STATE OF  
COLORADO

**Lost Creek 03-62-08-2H Rule 318A.f Sundry Notice Doc # 401268450**

Well Constructed 28444-   Quick Tools

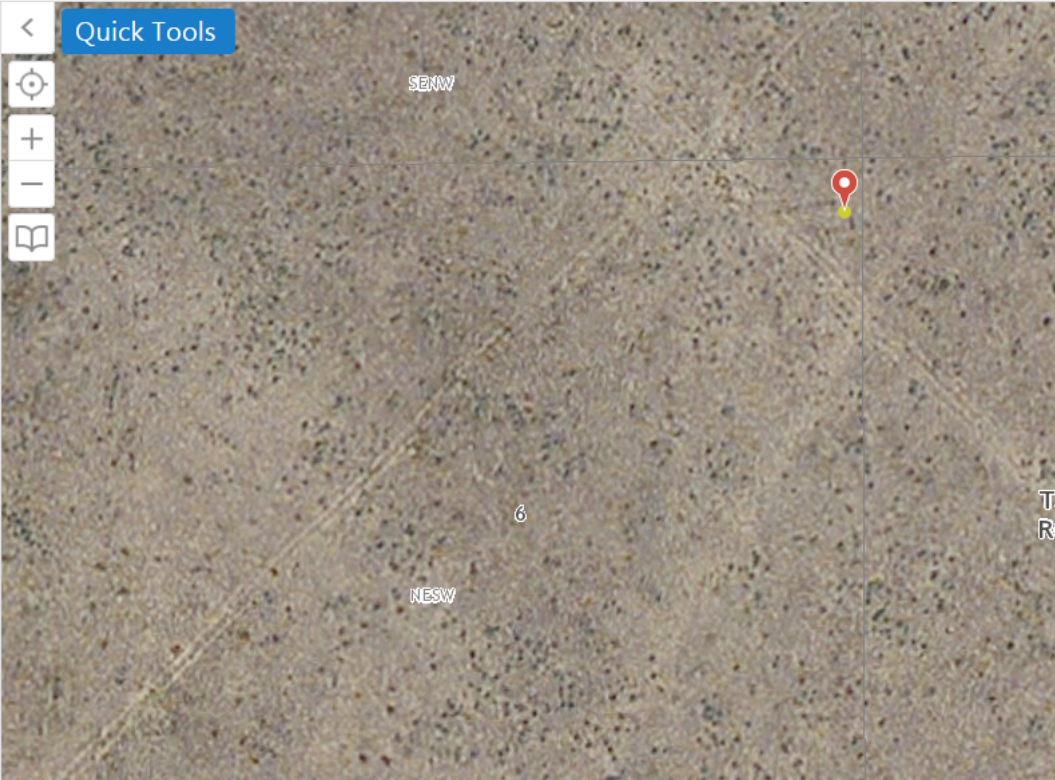
Prior to approving the above referenced Sundry Notice Verdad will need to address the the water well(Receipt Number 9063383, Permit Number 28444) highlighted below. The well falls within a quarter section that contacts the a 1/2 mile radius of the oil/gas well. Verdad will need to provide records of contact information or show that the well is not in the location shown below.

The map I used shows that well outside of the 1/2 mile quarter section. What map are you using?

If the DWR info is incorrect, I'll be happy to track that down and see if we can get a sample from this well, but seemed like it was outside the sampling area for 318.A.f.
